PUBLIC INTEREST REVIEW FOR GROUNDWATER APPLICATIONS

SUBJECT: Application G- 18146 Supersedes review of na
Date of Review(s)

A. GENERAL INFORMATION: Applicant's Name: Nancy Orem County: Clackamas

A1. Applicant(s) seek(s) 0.24 cfs from 1 well(s) in the Willamette Basin,
Molalla-Pudding subbasin

Water-Level Trends in Nearby Wells

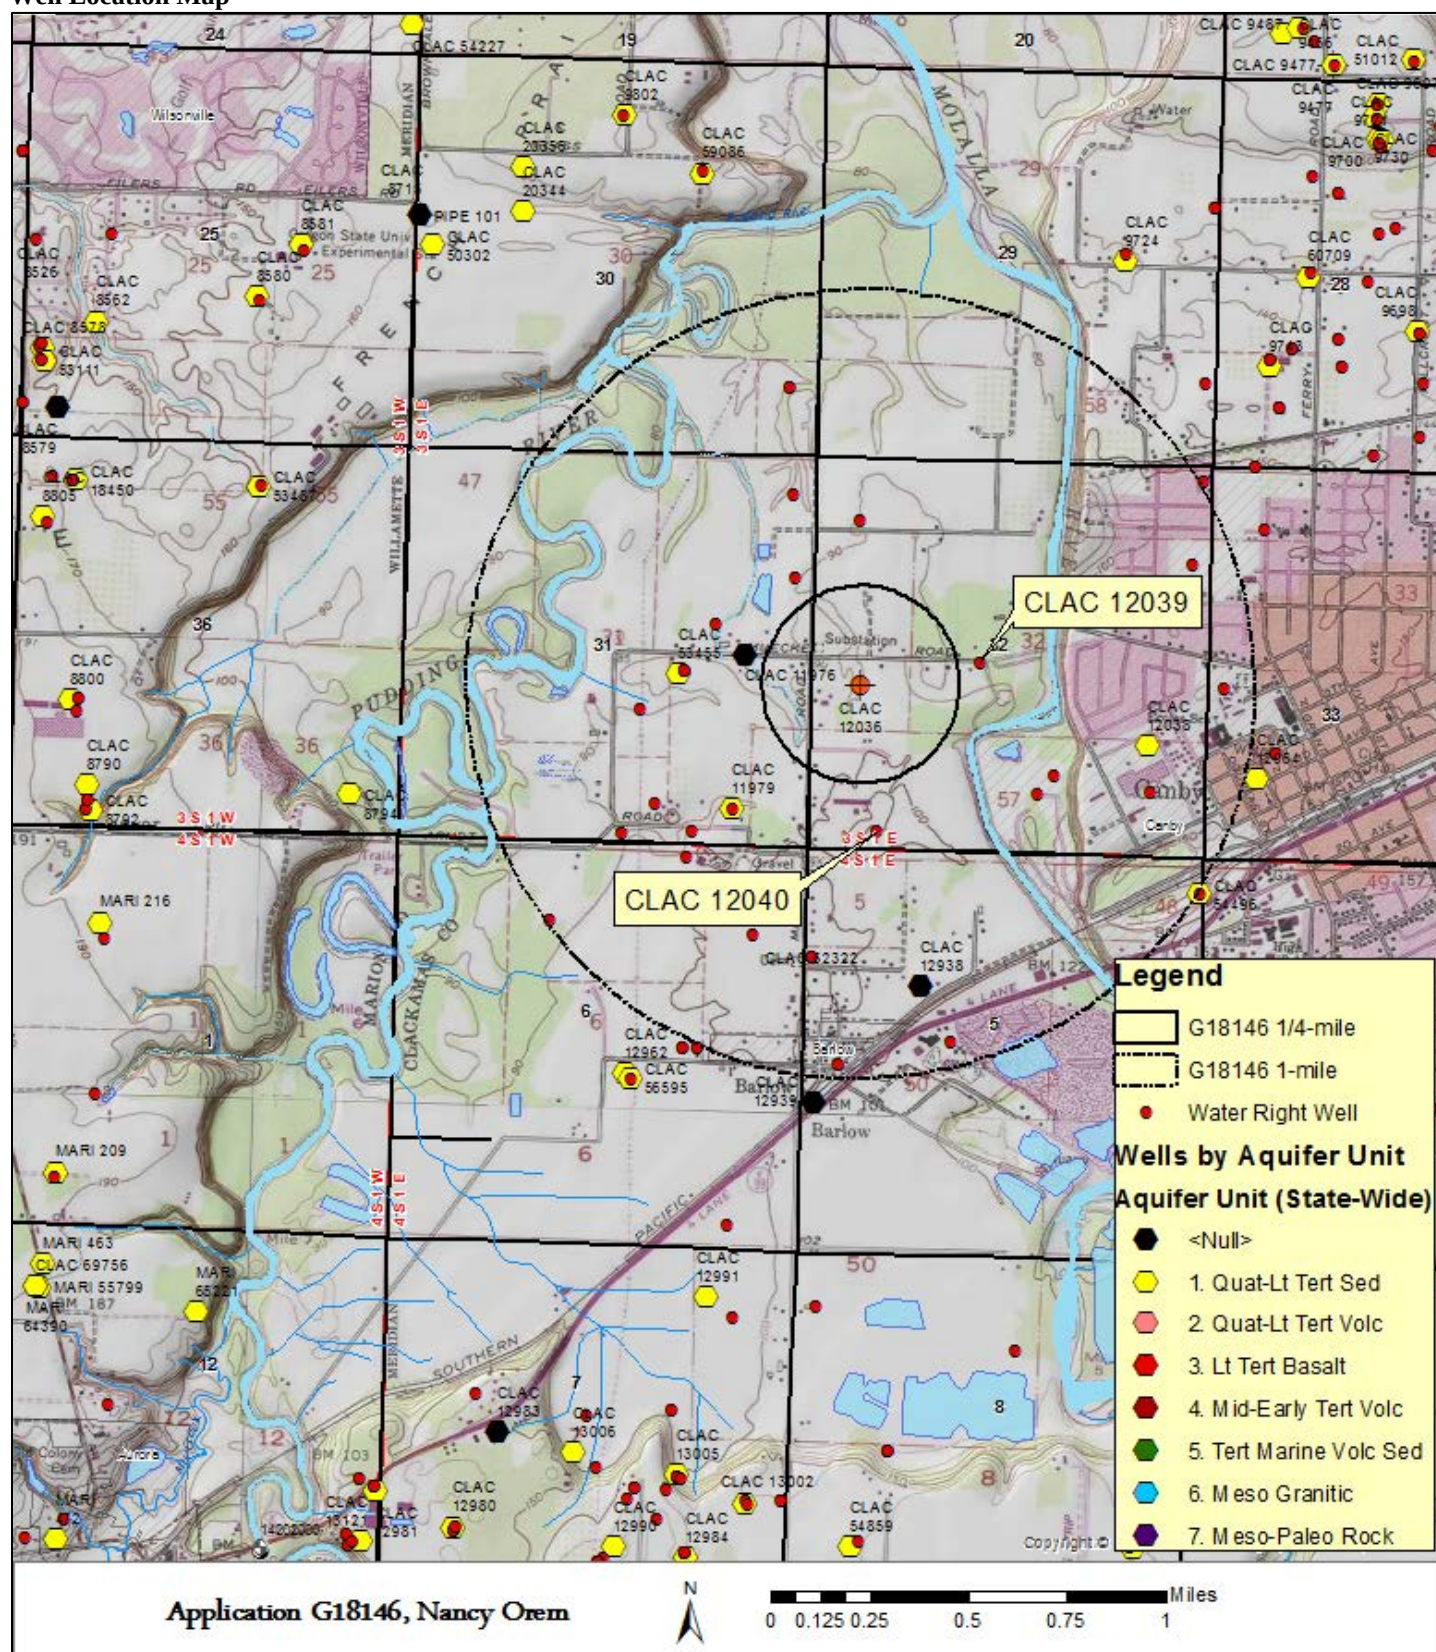
Groundwater observation data for wells within the floodplains between the Molalla and Pudding rivers where the aquifer is locally unconfined is limited to CLAC 8794 (highlighted in blue in the hydrograph below). Groundwater observation data for wells within ~1.5 miles from CLAC 12036, including wells completed on the terrace above the floodplain between the Molalla and Pudding rivers which are likely confined by low permeability Willamette Silt, show no long-term decline (see hydrograph below). This may indicate that, locally, the alluvial aquifer has an efficient connection to, and is fed by, the rivers.

Well Location Map

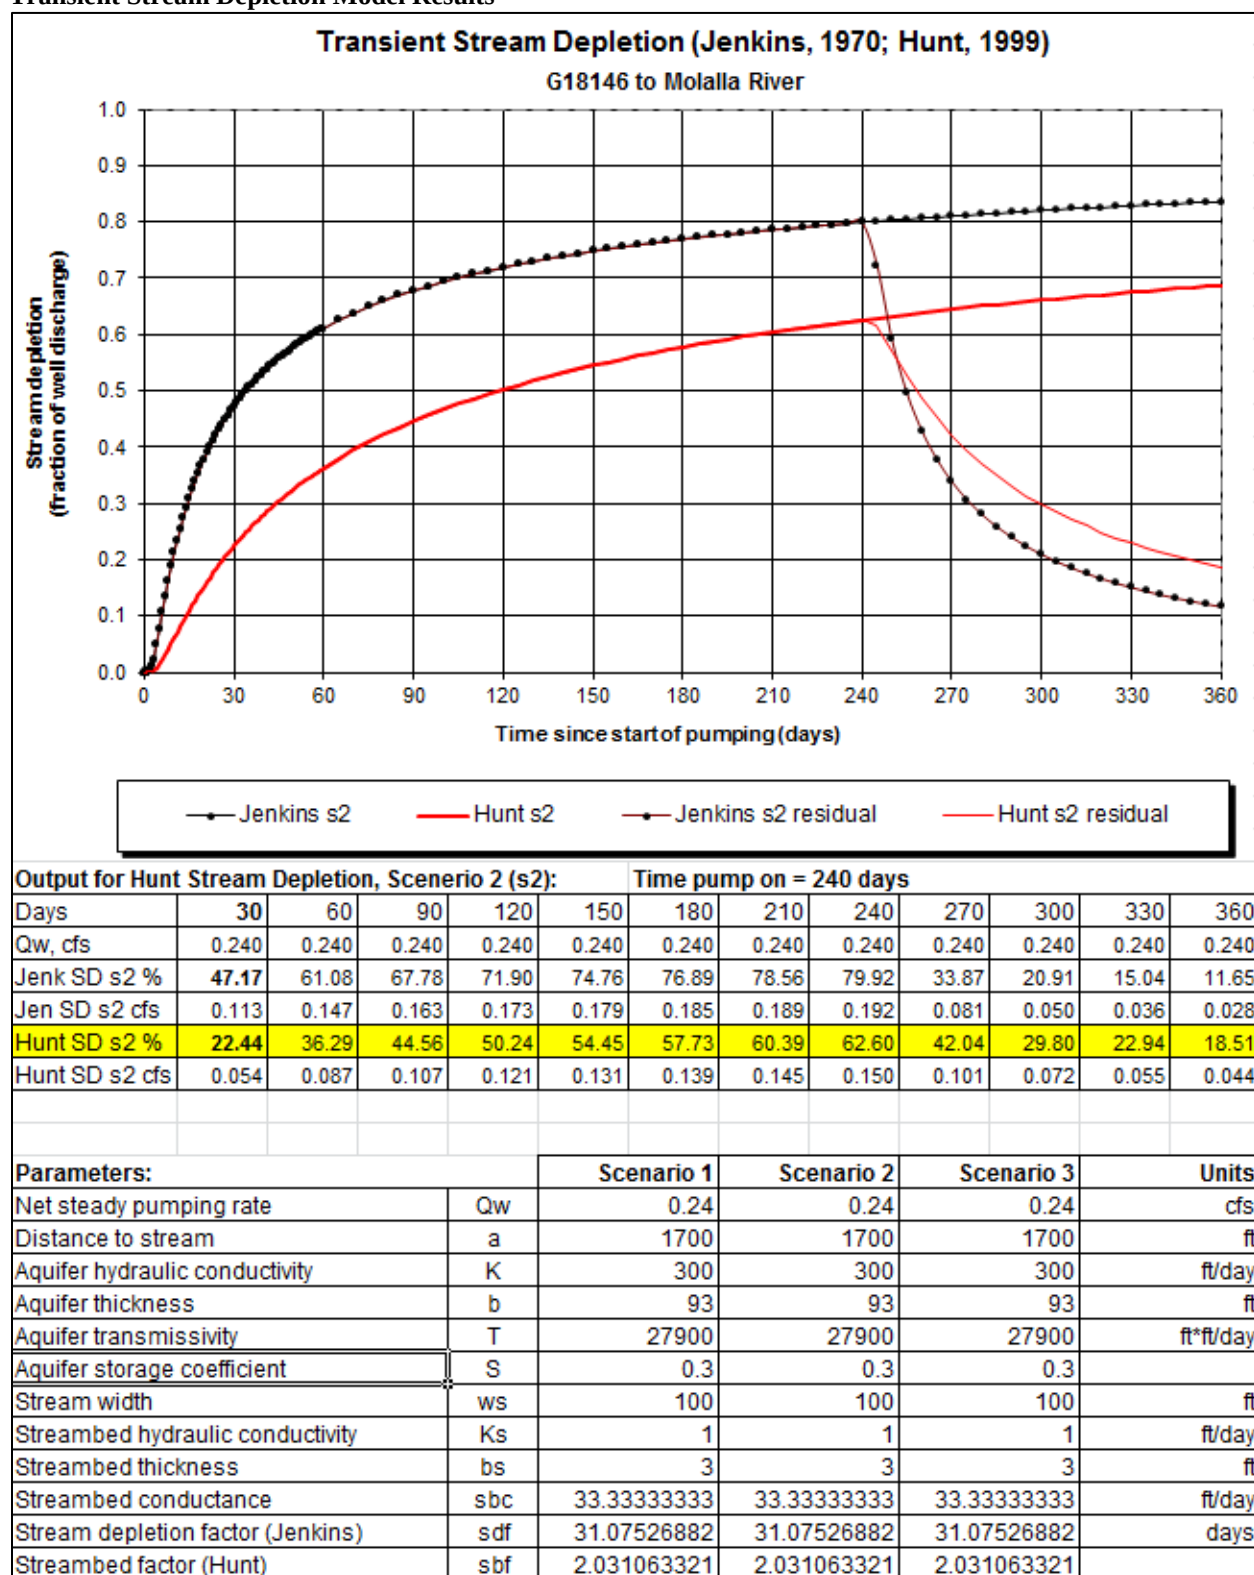
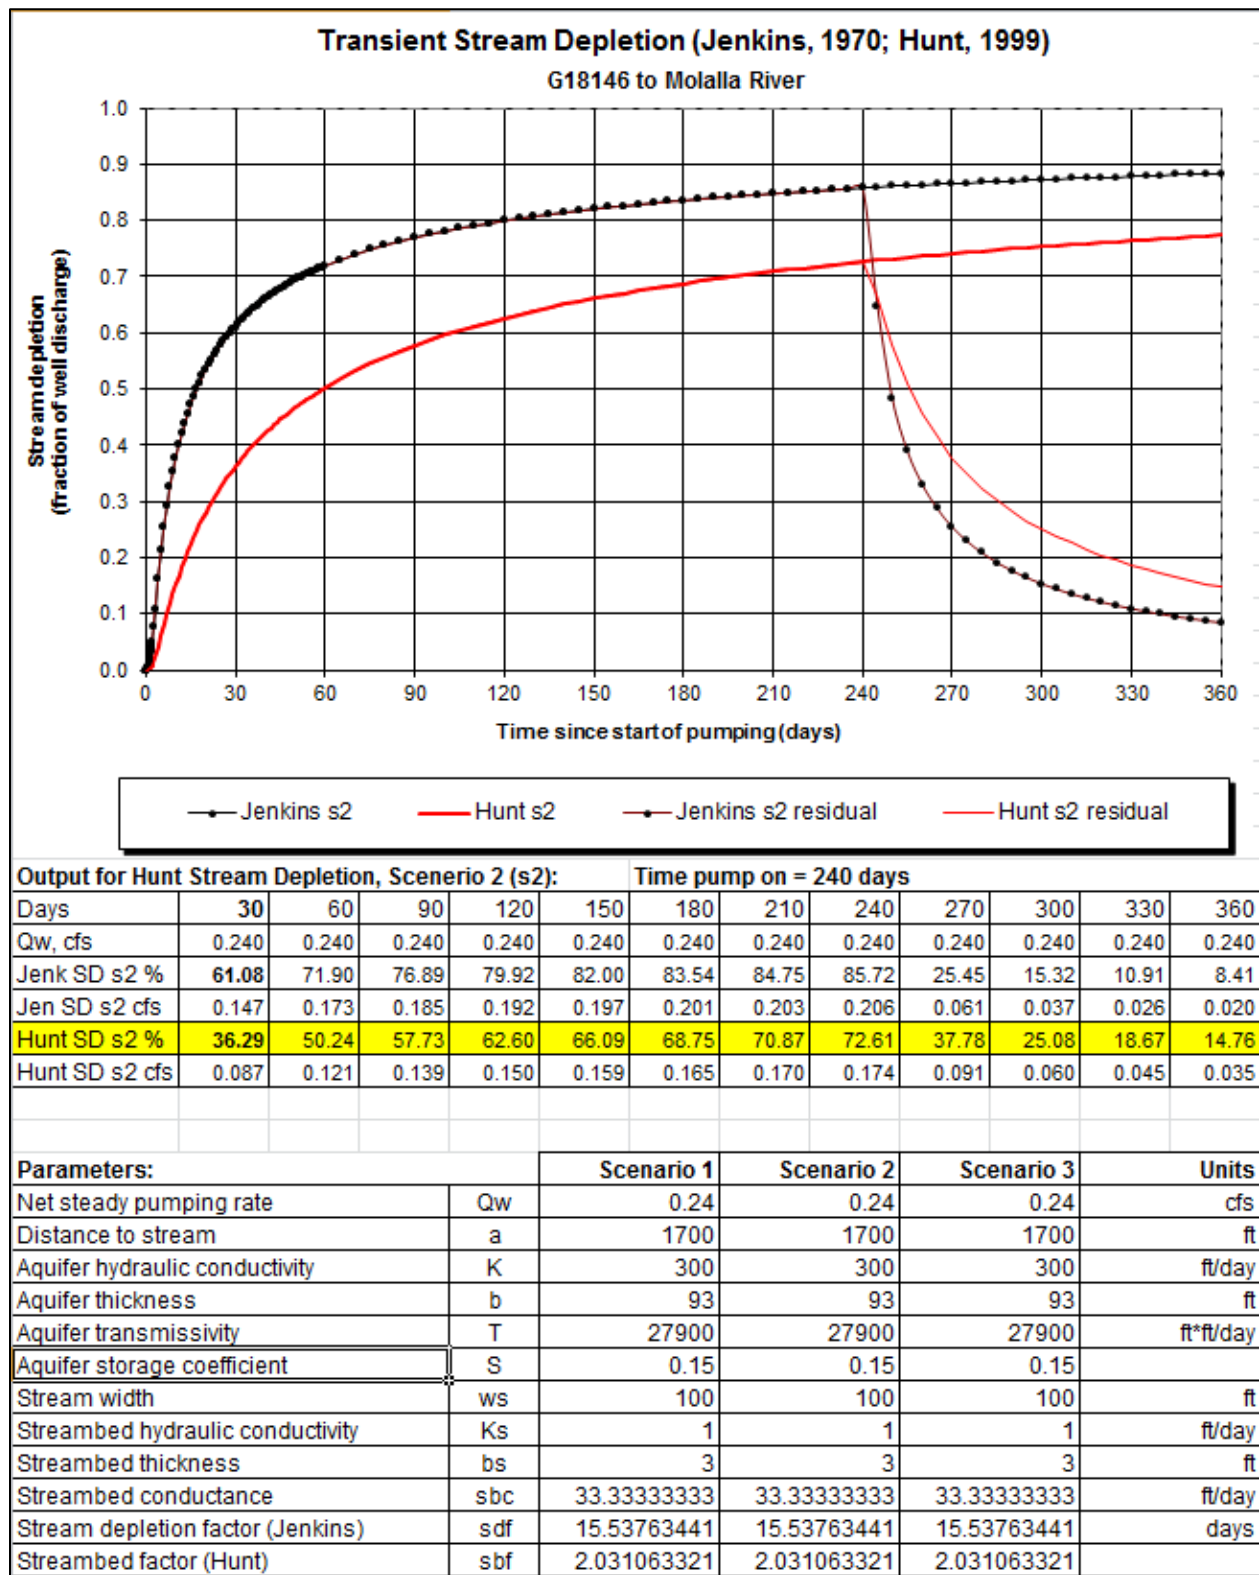
Well	SW #	Surface Water Name	GW Elev ft msl	SW Elev ft msl	Distance (ft)	Hydraulically Connected?			Potential for Subst. Interfer. Assumed?	
						YES	NO	ASSUMED	YES	NO
1	1	Molalla River	83	65-85	1,700	☒	☐	☐	☐	☒
1	2	Pudding River	83	65-75	3,780	☒	☐	☐	☐	☒
						☐	☐	☐	☐	☐
						☐	☐	☐	☐	☐
						☐	☐	☐	☐	☐
						☐	☐	☐	☐	☐

Basis for aquifer hydraulic connection evaluation: Published water-table maps indicate that locally, the groundwater flows towards, and discharges into, the Molalla and Pudding rivers.

Transient Stream Depletion Model Results

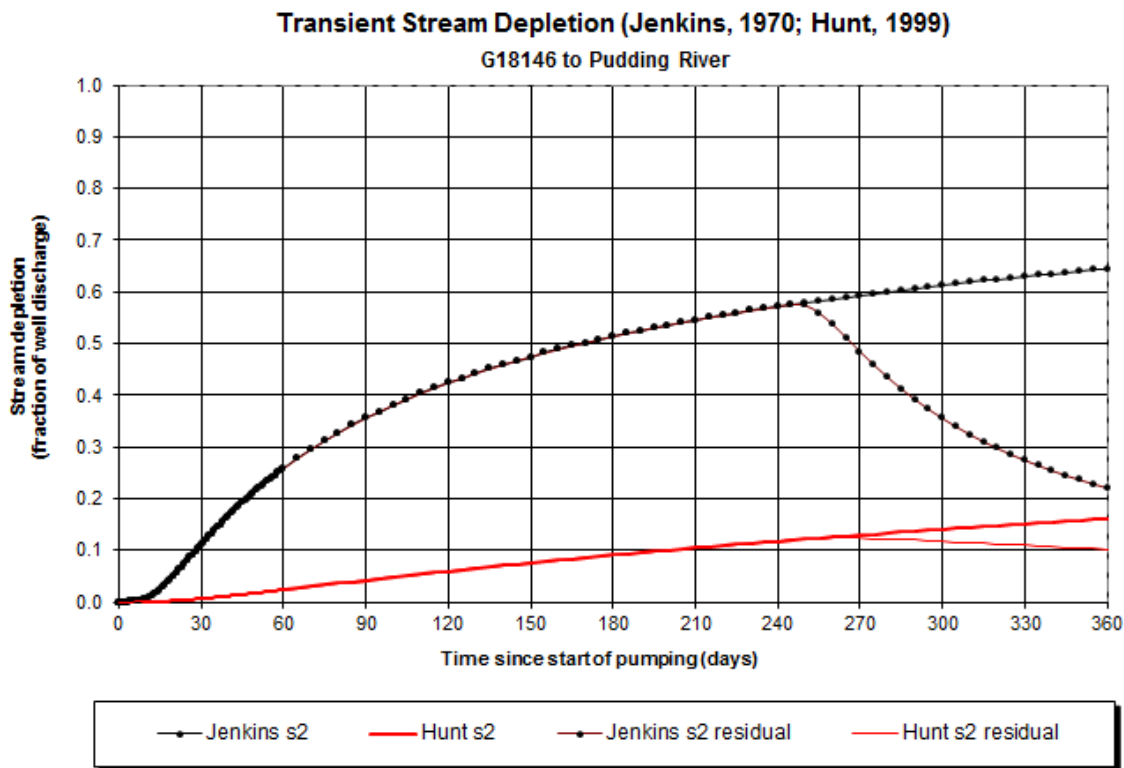
Comments: In the vicinity of CLAC 12036, any fine-grained material which may have been deposited has largely been eroded away. Water-bearing gravel or sand and gravel layers are encountered under a thin layer of topsoil. Since this area is lacking a confining layer, stream depletion was estimated using the Hunt 1999 model using a 3 foot clogging layer at the base of the stream. Depletion from each river was modeled separately, although in reality the well capture would likely come from some combination of the two rivers. An aquifer hydraulic conductivity value of 300 feet/day was used (mid-range for unconsolidated gravel deposits) for each model. For the aquifer specific yield, the models were run at a value of 0.15 (the low end for unconsolidated gravels, and 0.3 (the high end for unconsolidated gravels) (Driscoll, 1986).

Locally, the Molalla River has a cobble substrate (personal communication with Water Master Amy Kim, 12/3/2015), therefore a streambed hydraulic conductivity value of 1ft/day was used (on the low end of the range for a clean sand) (Driscoll, 1986). The interference estimates for the Molalla River at 30 days of pumping range from 22% - 36% (high-end to low-end range, respectively, for specific yield of unconsolidated gravels)

Locally, the Pudding River has a fine-sand to muddy substrate (personal communication with Water Master Amy Kim, 12/3/2015), therefore a streambed hydraulic conductivity value of 0.1ft/day was used (mid-range value for sands and silts) (Driscoll, 1986). The interference estimates for the Pudding River at 30 days of pumping range from 0.62% - 2.37% (high-end to low-end range, respectively, for specific yield of unconsolidated gravels)
